Access Compliance Report Public Rights-of-Way (Curb Ramps)

Intersection ID: 10011741 Main Street: N_SHARON_AMITY_RD Cross Street: N/A Location: SE

ADA ID: F1A96673BEF6 Ramp Type: PerpDiag Initial Pass/Fail: Fail Overall Compliance: No Severity Score: 33.75

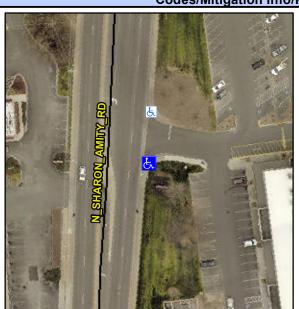
Not Found, R304.5.1, R304.5.3

Field Measurements/Component Compliance					
Co	Compliance Description		Comp	oliance Description	Data
N/	A Ramp Length (in)	59.0	Yes	Ramp Slope (%)	6.1
No	Ramp Width (in)	40.0	No	Ramp XSlope (%)	7.3
N/	A Flare Type LT	N/A	N/A	Flare Type RT	N/A
N/	A Flare Slope LT (%)	N/A	N/A	Flare Slope RT (%)	N/A
N/	A Flare Traversable LT?	N/A	N/A	Flare Traversable RT?	N/A
N/	A Landing Length (in)	N/A	N/A	DWS Provided?	N/A
N/	A Landing Width (in)	N/A	N/A	DWS Contrast?	N/A
N/	A Landing Slope (%)	N/A	N/A	DWS Length (in)	N/A
N/	A Landing X Slope (%)	N/A	N/A	DWS Full Width?	N/A
N/	A Landing Curb? (Y/N)	N/A	N/A	DWS Offset (in)	N/A
N/	A Shared Landing?	N/A			
N/	A Gutter Ponding?	N/A	N/A	Gutter Slope (%)	N/A
N/	A Gutter Lip Ht (in)	N/A	N/A	Gutter X Slope (%)	N/A
N/	A Painted X Walk1?	No	N/A	Painted X Walk2?	No
	X Walk 1 Direction	To N		X Walk 2 Direction	To W
N/	A X Walk 1 Width (in)	N/A	N/A	X Walk 2 Width (in)	N/A
	X Walk 1 Slope (%)	3.6		X Walk 2 Slope (%)	2.3

Remove & Replace Curb Ramp With Two New Directional Ramps or Equivalent.
